RESPONSE TO COMMENTS

Riverbend Landfill

Closure Permit Issuance

To: File and Interested Parties
From: James McCourt, Bob Schwarz and Seth Sadofsky
Date: August 31, 2022
Subject: Response to public comments for issuance of a solid waste disposal site closure permit for Riverbend Landfill

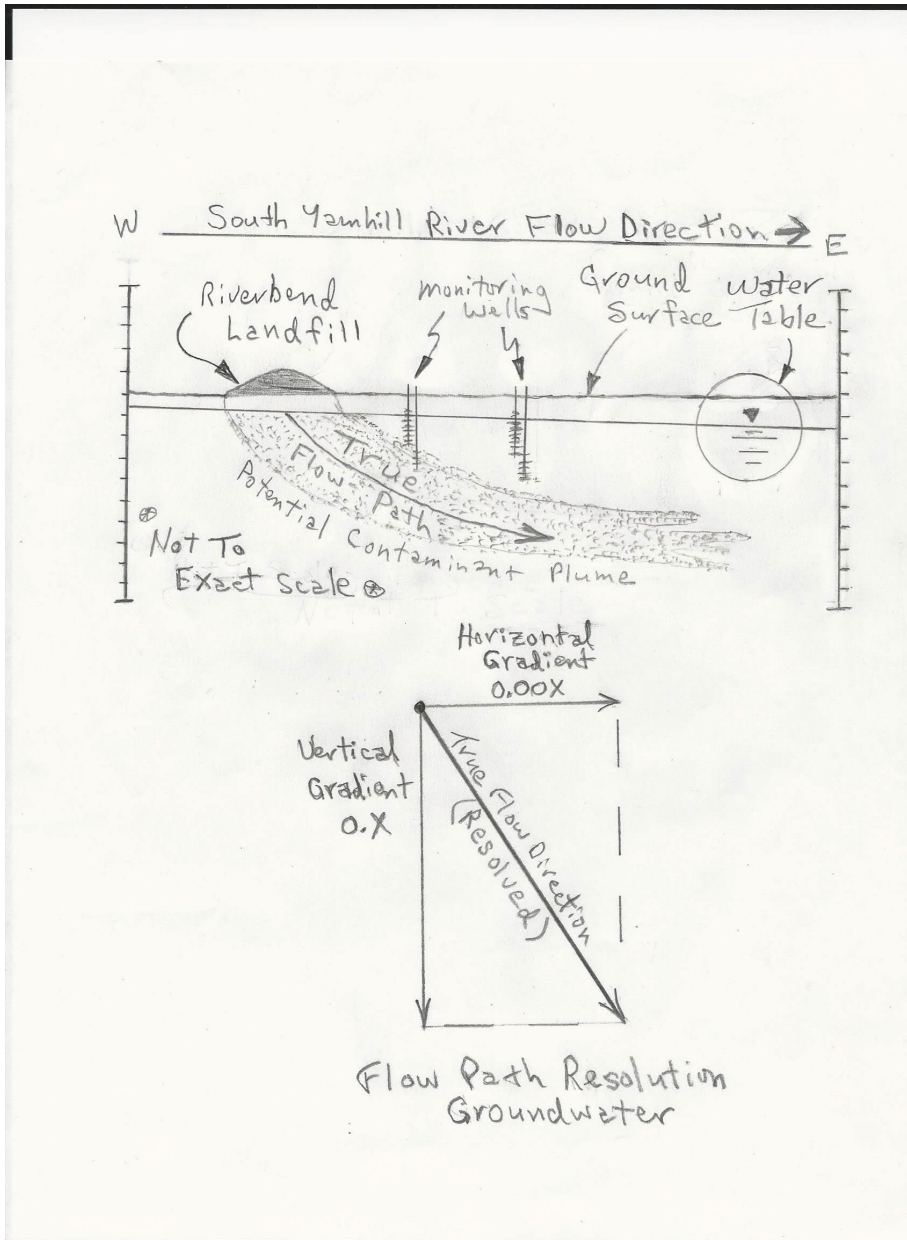
There is a known negative (down-ward) gradient in groundwater underlying RL. However, the full-extent and impact of the negative down-ward flow of groundwater, which also carries soluble/miscible contaminants deeper into groundwater, has not been characterized or even fully identified by WMI, or requested by DEQ. This has provided for a significant gap in groundwater monitoring data through time.

In any given location, negative or down-ward groundwater gradients are more commonly much larger than the horizontal gradient, often by two or three orders of magnitude. The impact of this phenomenon cannot be overstated because contaminants travel deep into groundwater in very little horizontal distance. Such negative and down-ward groundwater gradients provide for a contaminant plume that flows beneath and bypasses the present RL monitoring wells installed by WMI and approved by DEQ. Refer to Figure 1 for a West to East cross section through RL showing how a contaminant plume could migrate undetected beneath the RL groundwater monitoring system. Numerous real-life examples of this scenario have been characterized at many sites throughout the Central Valley of California and Southern California, with some plumes being miles in length.

DEQ RESPONSE: Vertical gradients are estimated at each monitoring well pair by comparing groundwater elevations in the shallow and deep well. This information is presented in Table 6-1 of the most recent AEMR, and is included in previous AEMRs. As noted in this comment, the groundwater gradient is downward at most locations. Contaminant migration is affected by groundwater gradients, but also by

The best measure of contaminant migration is not vertical gradients but the chemical concentrations found in the water samples. Based on the site's extensive groundwater monitoring network, groundwater quality meets the requirements specified in the DEQ-approved groundwater monitoring plan.

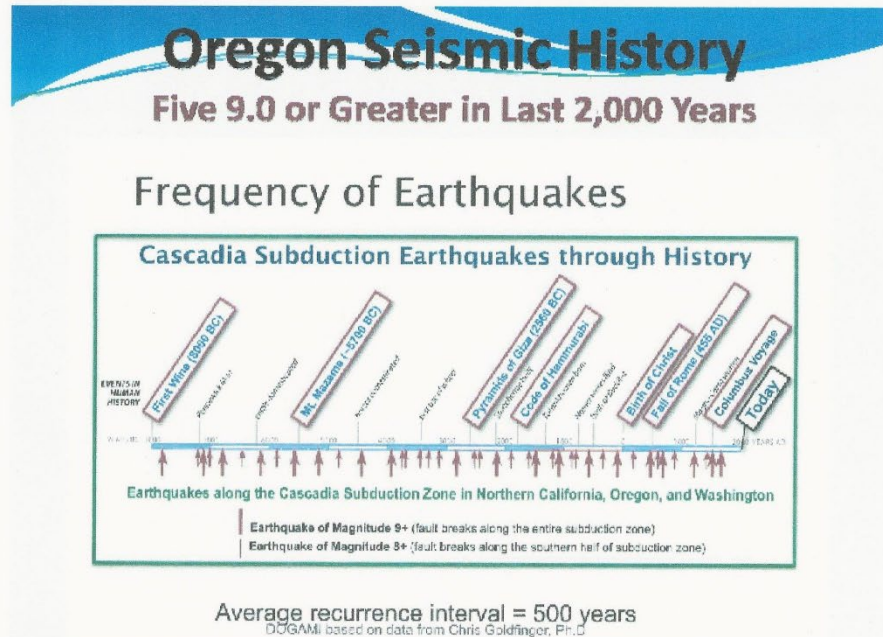
by a complete break of the CFZ, have occurred in the last 10,000-years; however, five of these Magnitude 9 earthquakes occurred in the last 2,000-years (Refer to Figure 2 for a partial accounting of significant PNW earthquakes). Besides Magnitude 9 events, many magnitude 6, 7, and 8 earthquakes also occurred with epicenters within 100-miles of the Pacific coast. The last full-break CFZ earthquake is well-dated and occurred in late January 1700, more than 100-years before the arrival of the Lewis and Clark expedition. Given that five major earthquakes have occurred in the last 2,000 years and that the last Magnitude 9 CFZ earthquake was 322-years in the past, places the PNW well into the window for a repeat full-break of the CFZ that will result in a Magnitude 9 devastating earthquake. How could WMI propose and DEQ accept the total closing cost amount now set at a maximum cap of \$15,425,086 given this pending earthquake threat? How could they and who will pay for remediating a total failure of RL??

When the MSE Berm was being permitted, geologic data, confirmed by WMI laboratory analysis, showed that even though the landfill itself may be stable when exposed to a magnitude 9 earthquake, the geologic foundation for the landfill would fail by foundation liquefaction during an earthquake of even moderate magnitude. Totally overlooked (disregarded-?) in the RL Closure Plan was any mention of these liquefaction data and the single largest long-term threat to RL: Earthquakes. For a partial review of WMI liquefaction data, confirmed by laboratory analysis, refer to Attachment 1 (Liquefaction Review Paper) and Attachment 2 (Liquefaction Updated - 2017) below.

DEQ RESPONSE: As discussed above, liquefaction was evaluated in detail during DEQ’s review of seismic evaluation and design submitted as part of a proposal to construct a mechanically stabilized earthen berm. This review was conducted between 2011 and 2013. Waste Management’s consultant, Geosyntec, provided a substantial amount of geotechnical testing data over several months in response to review by DEQ and its own geotechnical consultant. Soil characteristics were determined based on visual classification and standard penetration tests in the field, followed by soil lab testing. In addition, a geophysical survey was conducted to obtain shear wave velocity information for site soils.
